# INDIANA DEPARTMENT OF TRANSPORTATION

## FINAL DRAFT MINUTES

### March 20, 2026, Standards Committee Meeting

RE: Minutes from the March 20, 2026, Standards Committee Meeting

<b>INDIANA DEPARTMENT OF TRANSPORTATION</b>	
<b>SAWED JOINTS AND JOINT SEALANT</b>	
SEPTEMBER 2020 - 2026	
STANDARD DRAWING NO. E 503-CCPJ-02	
	 DESIGN STANDARDS ENGINEER      03/10/20 DATE
	 CHIEF ENGINEER      05/08/20 DATE

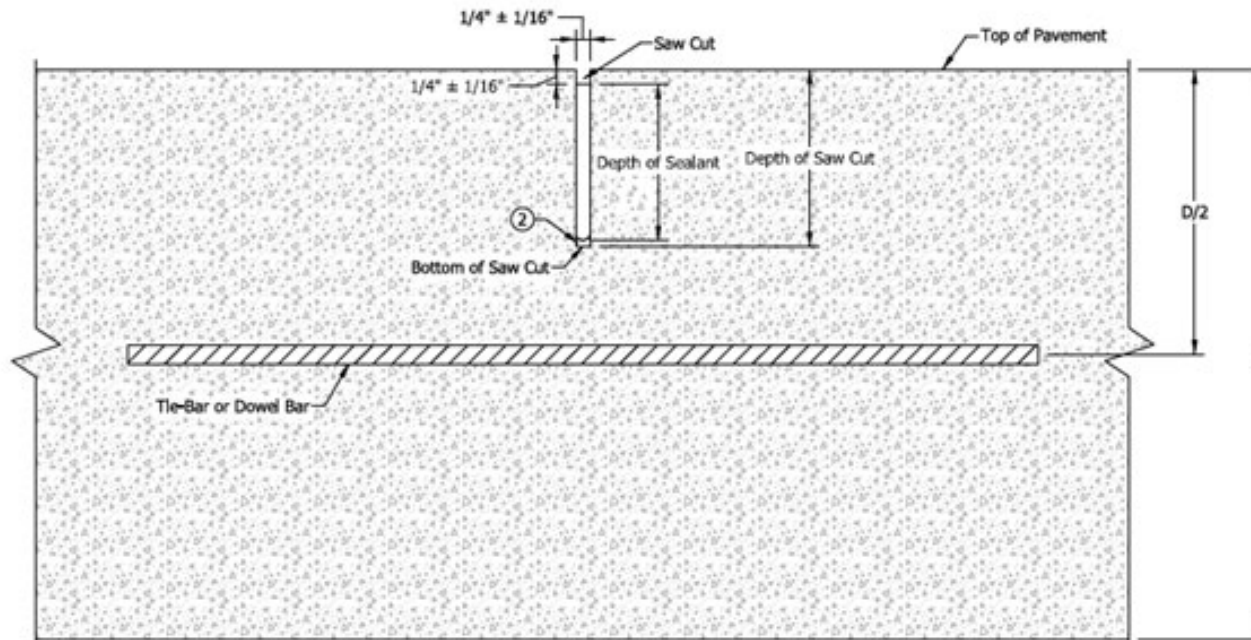
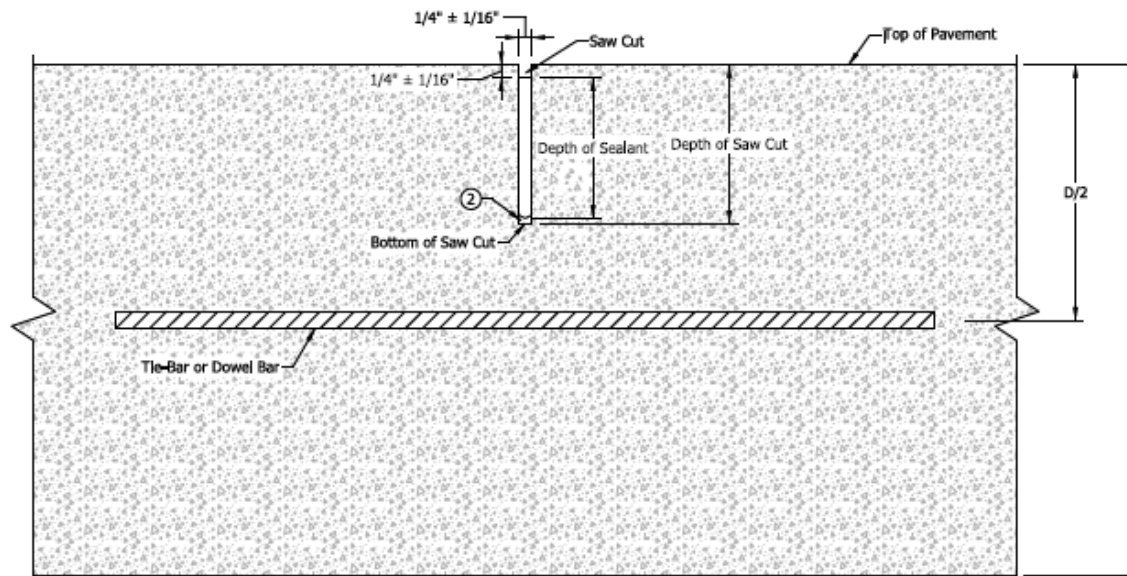
APPLICABLE STANDARD DRAWING: 506-CCPP with corresponding changes to terminology in 503-CCPJ-02

1. Multiple passes of sealant may be required.
- ② Backer rod shall not be installed.
- ③ For Retrofit Transverse Joint details, see Standard Drawing Series E 506-CCPP.

E 506-CCPP-02 JOINT DETAILS (WITH SHOWN MARKUPS)

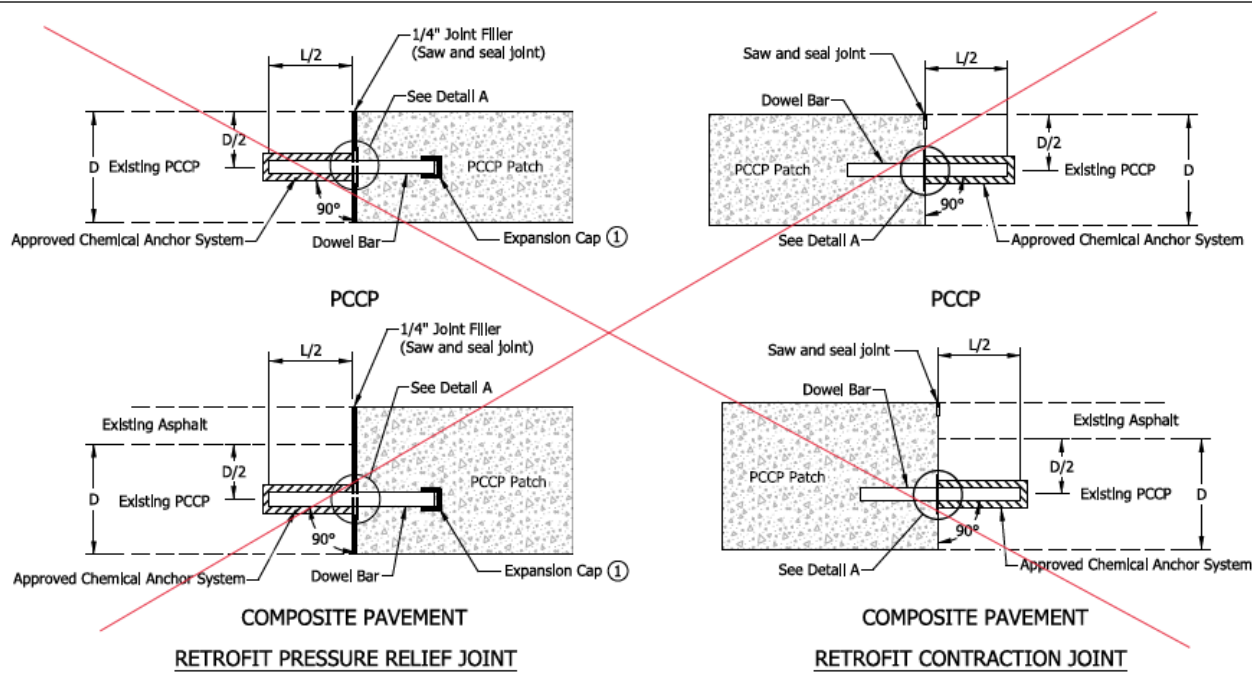
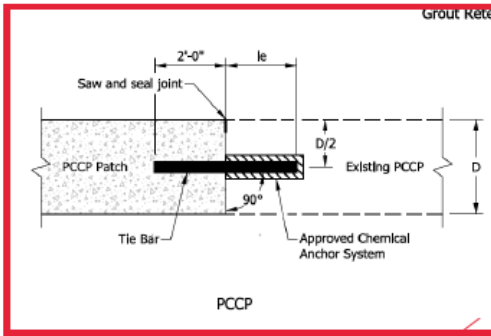
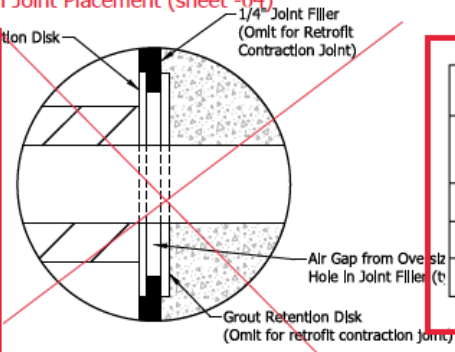
Combine new Retrofit Transverse Joint details with Joint Placement (sheet -04)

add new detail for composite pavement

In reference to drawing 506-CCPP-04, Mr. Koch stated that he is uncertain as to our expectations, usually deformed bars are depicted with hatching. Are we intending smooth or deformed retrofit transverse joint tie bars? Observing the installation of retrofit bars over the years, it is a struggle for a crew to consistently

glue the bars into the correct plane. I tend to believe/assume most retrofit joints will be locked due to out of plane bars. Mr. Dave agreed and stated that the dowels bars shall be deformed, as stated above.

In reference to drawing 506-CCPP-04 (05 & 06), Mr. Koch suggested that, in order to avoid confusion as deformed bar is preferred at the construction joint, please consider amending the thickness of the depicted tie bar in a manner that differs from d-1 / dowel bars, similar to 503-CCPJ-02.

- Updated hatch of tie bars to align with the 503-CCPJ series.
- Removed hatch of dowel bars to remain consistent with the 503-CCPJ series.
- Added a new saw-cut detail to Sheet -03 to address the potential for diagonal cracking in the lane when a longitudinal saw cut is made at a narrow shoulder. Based on discussions with Nick Cosenza, the cracking risk appears to stem from pouring the lane and shoulder monolithically (16-ft slab). Added new Note 6.
- Revised Sheet -03, Note 1 to allow epoxy in lieu of hot pour, as approved.
- Revised the table on Sheet -04 to specify a minimum 1'-0" embedment (le) for all tie bar sizes.

INDIANA DEPARTMENT OF TRANSPORTATION	
JOINT PLACEMENT	
SEPTEMBER 2020 2026	
STANDARD DRAWING NO. E 506-CCPP-03 04	
	 DESIGN STANDARDS ENGINEER 03/10/20 DATE
 CHIEF ENGINEER	05/01/20 DATE

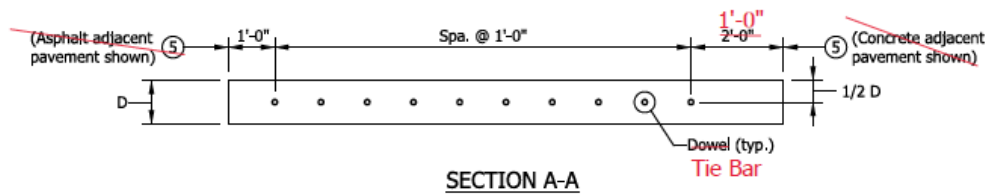
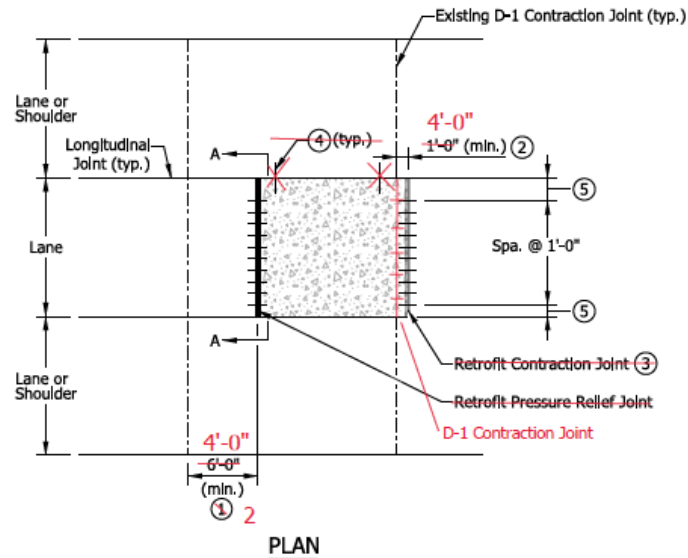
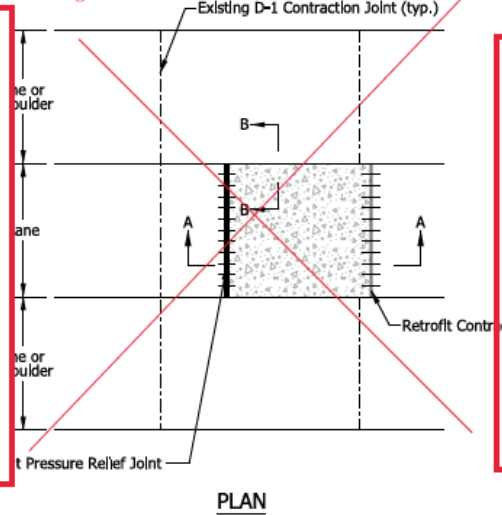
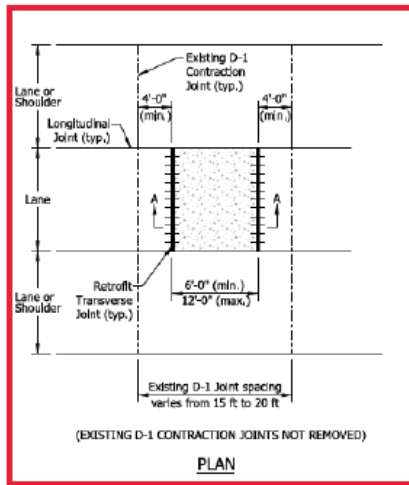
Add new detail for sawcut removal (sheet -03)

Combine these details with new Retrofit Transverse Joint details (sheet -04)

1. Retrofit Transverse Joint shall be placed at each end of the patch.
- ② Retrofit Transverse Joints shall be placed a minimum of 4 ft from an existing D-1 Contraction Joint.
3. Sawing and sealing joints shall be omitted where the concrete patch is to be overlaid with asphalt or concrete.
4. Tie bar size and embedment (e) shall be as shown on table this sheet.

INDIANA DEPARTMENT OF TRANSPORTATION	
PATCH LENGTH $\geq 6'$ AND $\leq 15'$ 20	
SEPTEMBER 2020 2026	
STANDARD DRAWING NO. E 506-CCPP-04 05	
(COMPOSITE PAVEMENT SHOWN)	(PCCP SHOWN)
PAVEMENT SECTION A-A	PAVEMENT SECTION A-A
03/10/20	DATE
05/01/20	DATE

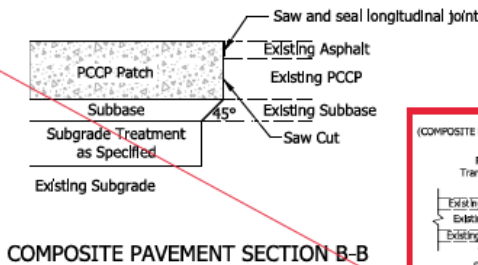
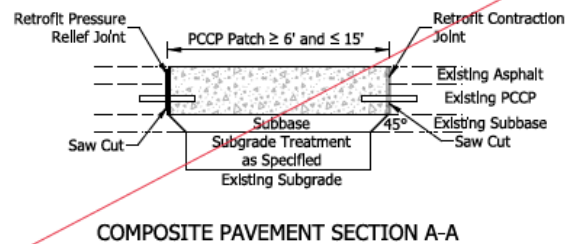
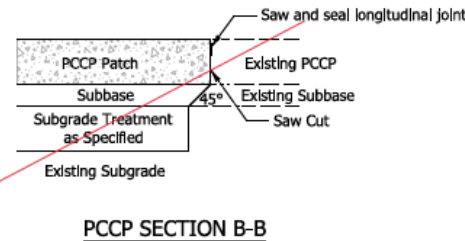
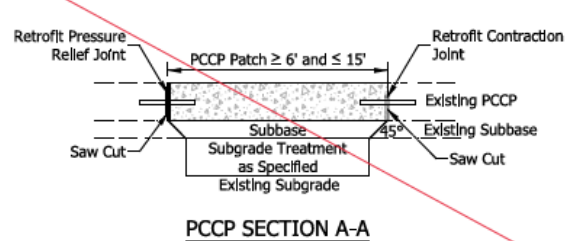
Replace with two details - one between existing D-1, one that removes existing D-1

new notes

REPLACE with a single pavement section

1. Minimum and maximum patch lengths based on existing D-1 Contraction Joint spacing and minimum 4 ft distance to Retrofit Transverse Joint.

2. For patch lengths 6 ft or greater and less than 20 ft, tie bars shall not be placed at longitudinal joints.
3. Where the distance from an existing D-1 Contraction Joint to the end of the patch is less than 4 ft, the patch length shall be extended until the minimum distance is satisfied. Where extending the patch results in a patch length greater than 20 ft, use detail on Standard Drawing E 506-CCPP-06.

4. See Standard Drawing E 506-CCPP-04 for transverse tie bar spacing.
5. Where the patch length is 12 ft or less and the existing D-1 Contraction Joint has not been removed, a D-1 Contraction shall not be placed.

<b>INDIANA DEPARTMENT OF TRANSPORTATION</b>	
<b>20'</b> <b>PATCH LENGTH &gt; 15' AND ≤ 60'</b>	
SEPTEMBER 2020 2026	
STANDARD DRAWING NO. E 506-CCPP-05.06	
	<p><i>Elizabeth W. Phillips</i> DESIGN STANDARDS ENGINEER      03/10/20 DATE</p> <p><i>Mr. Dave</i> CHIEF ENGINEER      05/01/20 DATE</p>

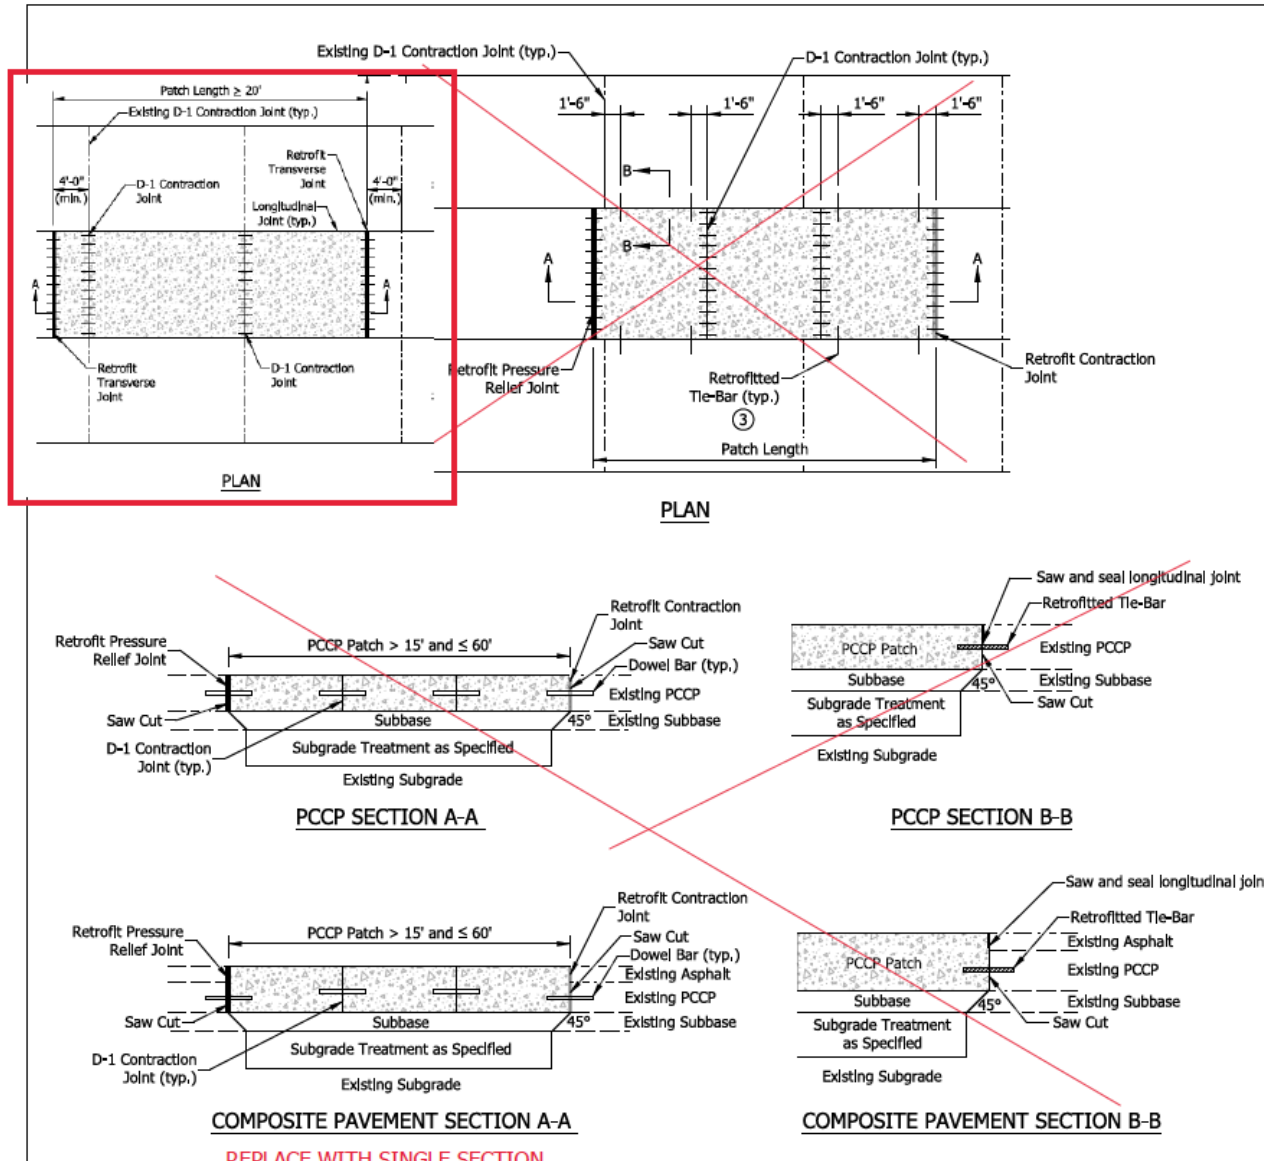
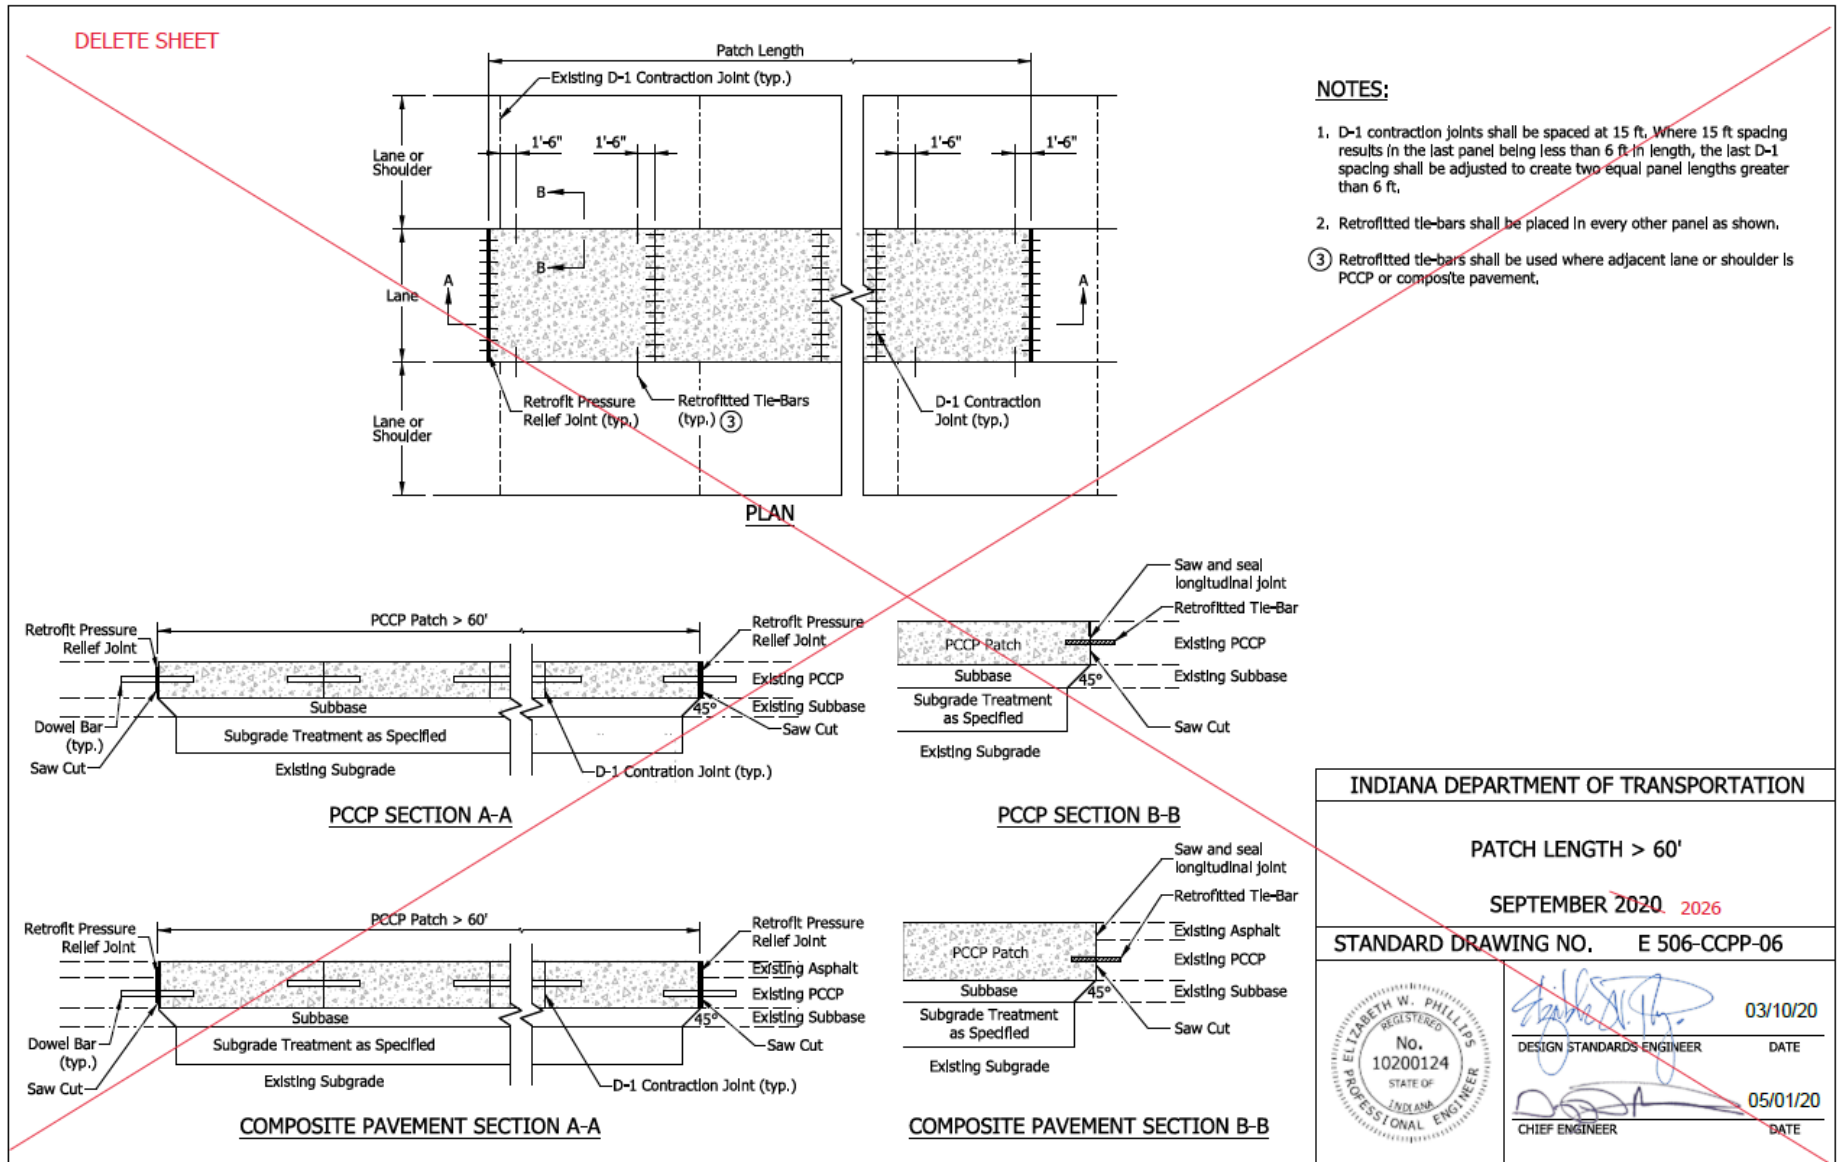
**new notes**

REPLACE WITH SINGLE SECTION

1. D-1 Contraction Joints shall be matched with spacing of the existing D-1 Contraction Joints of adjacent lane or shoulder PCCP.
2. For composite pavement, the PCCP patch D-1 Contraction Joints shall be placed with a maximum spacing of 16 ft, if contraction joints are not apparent in the adjacent lane or shoulder.
3. For a patch length greater than 100 ft, longitudinal retrofitted tie bars shall be required and installed as shown on Standard Drawing E 503-CCPJ-02.
4. See Standard Drawing E 506-CCPP-04 for tie bar spacing.

STANDARD DRAWING NO. E 506-CCPP-07-02

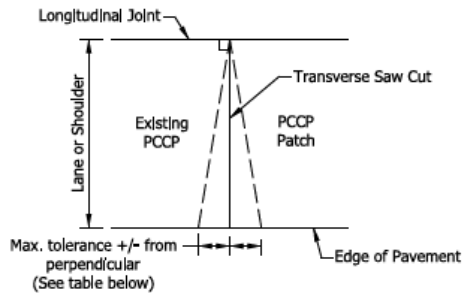
Move contents to Sheet -02

INDIANA DEPARTMENT OF TRANSPORTATION	
SAWCUT REMOVAL DETAILS	
SEPTEMBER 2026	
STANDARD DRAWING NO.	E 506-CCPP-03
DESIGN STANDARDS ENGINEER	DATE
CHIEF ENGINEER	DATE

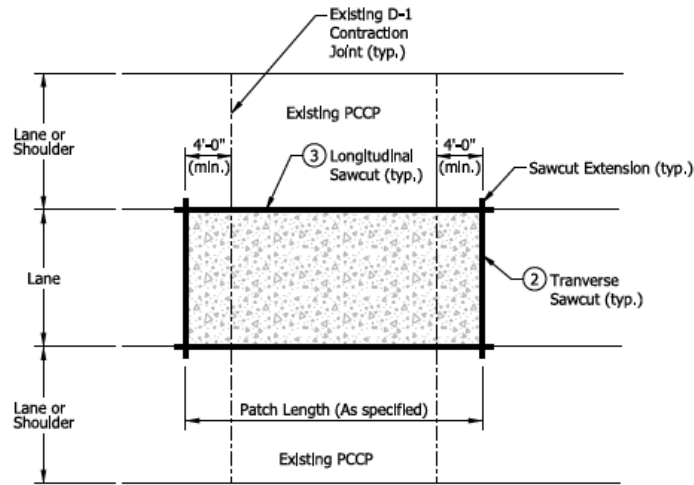
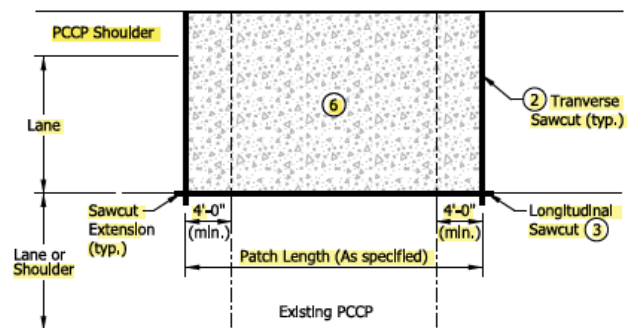
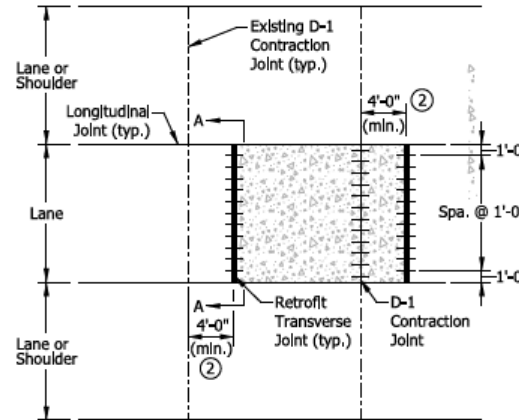
In reference to drawing 506-CCPP-03, Mr. Koch stated that the goal is to cleanly remove the area to be patched without the need for excessive jackhammering to minimize damage and gain efficiency. Mr. Koch also mentioned that 12 in. overcut is not enough in most situations due to the variations in depth of the existing pavement, since 12 in. PCCP is not typically 12 in., and for composite roadways. Please increase the overcut to a max of 2 ft with epoxy filling the cut. Mr. Koch asked to please consider including a note stating that 'The allowable overcutting shall not alter the planned MOT'. Hoping to avoid an inefficiency claim if the MOT only allows for a foot offset.

1. Allow max 16 in. overcut, 18 in. could be ok if we prefer a round number.  
Please do include a plan note stating that the MOT cannot be altered.
2. Fill the overcut with a semi thick epoxy  
Same material as the chemical anchoring system as the material is on hand  
The epoxy will not puddle into the working joint, simple materials could be used to dike the epoxy such as cardboard/thin wood.

Mr. Sipes stated that, regarding the 12 in. max oversaw, the dimension of oversaw needed to fully saw through the existing concrete depending on the depth of the concrete pavement and the diameter of the saw blade being used. I believe the intent is to eliminate damage to the bottom half of the pavement adjoining the patch by saw cutting all the way through the pavement in the corners. The detail and note for the oversawing should allow enough flexibility to determine the length of oversaw required to achieve the goal. In some cases, 12 in. will not be sufficient, which may be one of Mr. Koch's concerns.

Mr. Dave responded that the goal of overcutting is to remove the existing pavement without jackhammering or chipping manually. There seems to be few options as described by Mr. Nantung. However, in reality, the contractor will not change the blade or use vertical saw to remove the existing pavement for the patching. Though the 12 in. overcut will be ok for most of the pavement, we can increase overcutting to max 14 in. or 16 in. to cover thicker pavement if everyone agrees. We don't want to initiate cracks beyond overcutting.
